Design & Access Statement Addendum

Prepared by Lechler Hayes Architects on
behalf of Tiger Developments Ltd.

20.02.23

This report has been prepared by Lechler Hayes Architects (LHA) in response to comments received from Manchester City Council Officers in relation to the proposed design for the Carmoor Road development.

CGI SHOWING THE PROPOSED DEVELOPMENT ALONG CARMOOR ROAD

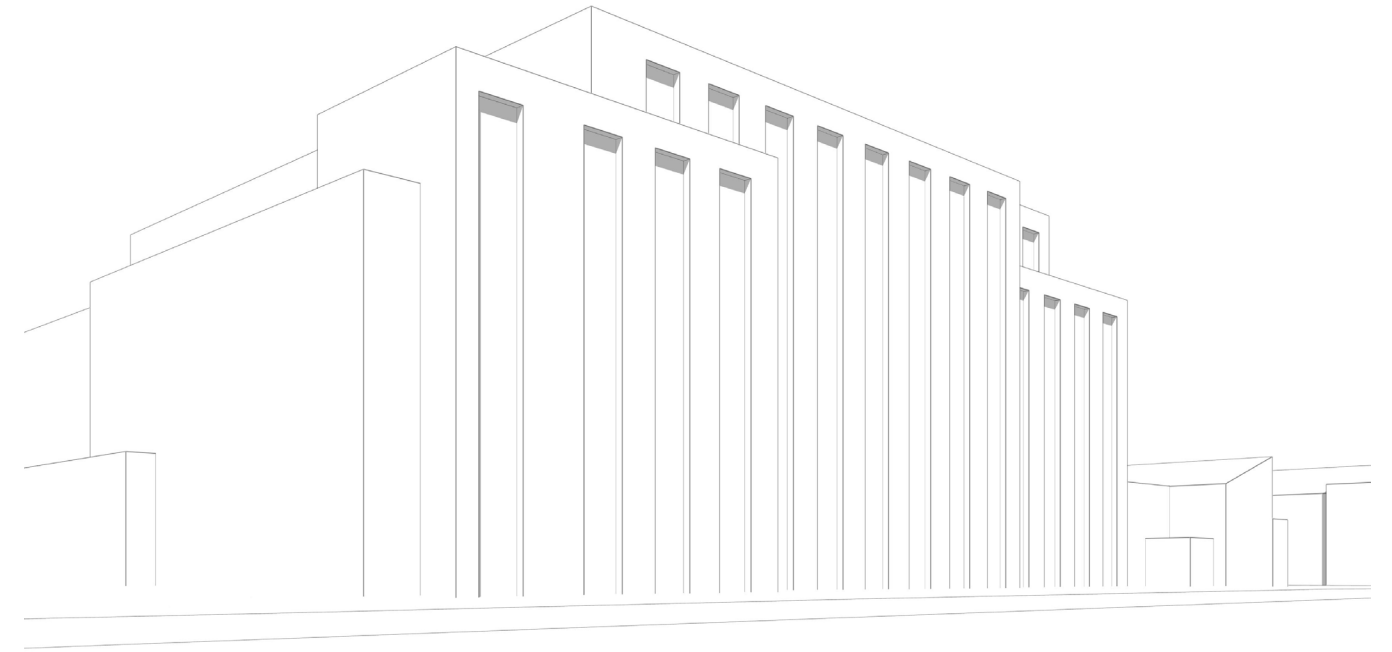
The comments fall under the following headings:

- Facade design approach
- Window detailing including reveal depth, glazing size, ventilation, screen design and finishes.
- Cycle Parking provision

- DEEP PUNCHED OPENINGS CREATE A SENSE OF WEIGHT AND GENERATE A STRONG, VERTICAL RHYTHM WHICH BREAKS DOWN THE FACADE INTO A SERIES OF SMALLER 'BAYS'.

- TRIPLE SOLDIER BRICK COURSE AT LEVEL 01 BREAKS THE VERTICAL BAYS AND INTRODUCES A HORIZONTAL DATUM AROUND THE BUILDING AT STREET LEVEL.
- UPPER FLOORS EXPRESSED HORIZONTALLY THROUGH LOUVRE PANELS IN GLAZING.
- LARGER OPENINGS AT GROUND LEVEL ACTIVATE THE FRONTAGE AND PROVIDE LEGIBILITY TO THE CARMOOR ROAD ENTRANCE.

- ELEVATIONAL FRAME EXPRESSED THROUGH RELATIONSHIP BETWEEN WINDOW BAYS AND SOLID BRICK PIERS. THE COMPOSITION IS INTENDED TO ACCENTUATE THE VERTICALITY BUT WITH A SUBDIVISION THAT IS CONTEXTUAL AND HUMAN IN SCALE.
- ALTERNATING RECESSED BRICK COURSE DETAIL ADJACENT TO OPENINGS REINFORCE THE WINDOW BAY TREATMENT AND ADD LAYERING AND TEXTURE TO THE FACADE. THE SECTIONS OF RECESSED BRICK COURSING WILL ALSO CREATE AREAS OF LIGHT AND SHADOW WHICH WILL VARY THROUGHOUT THE DAY.

ANODIC BRONZE COATING, COLOUR: MATT BRONZE

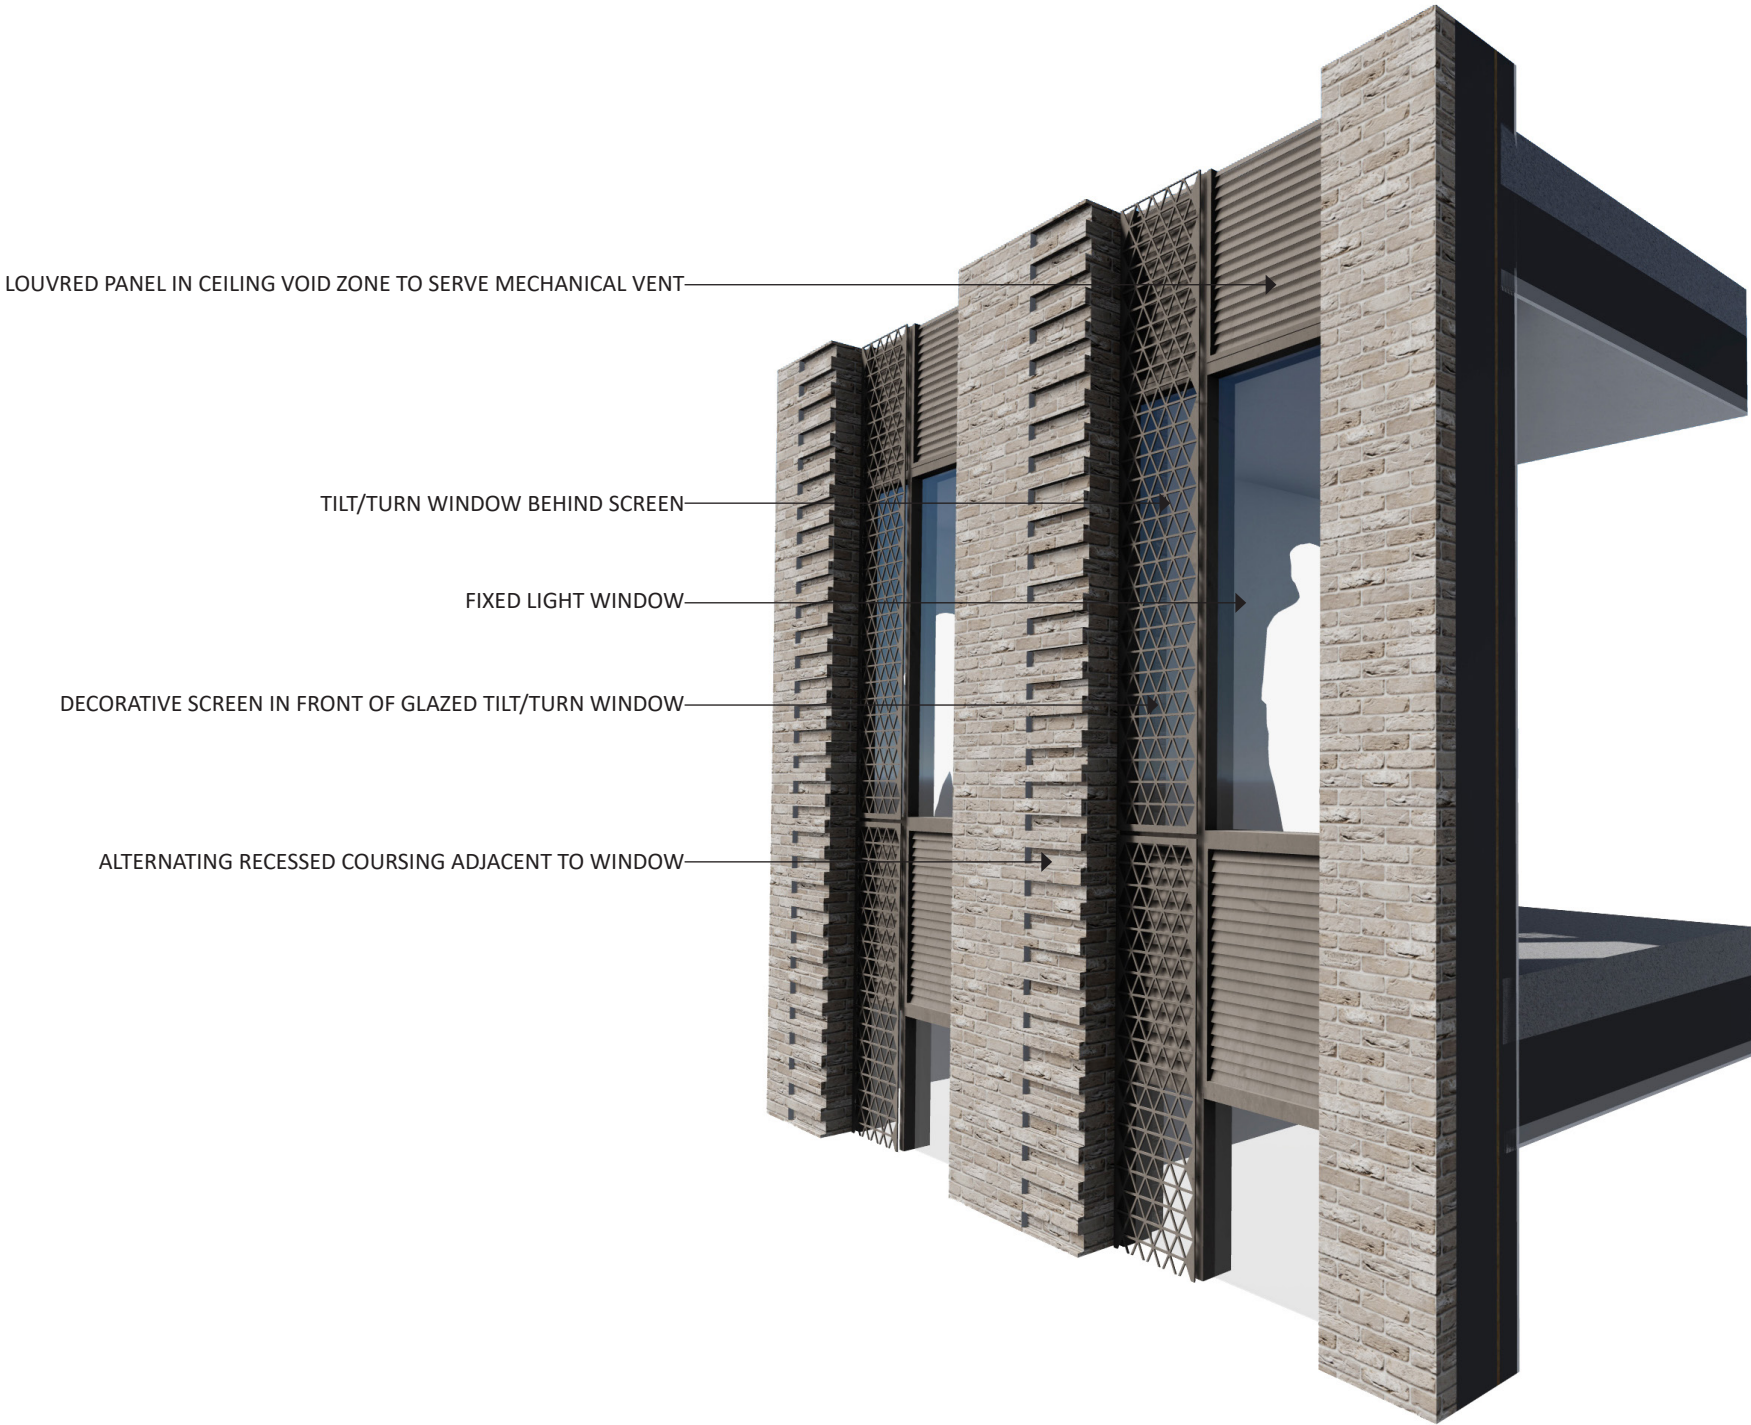
Clarification has been requested regarding the finish of the window frames and decorative screens. MCC officers have suggested an anodised finish.

The submitted drawings refer to a powder coated finish to the metalwork (window frames, screens, parapet cappings). In response to comments, we propose an enhancement to the original specification to an anodic coating which provides a metallic finish using a durable polyester powder coating.
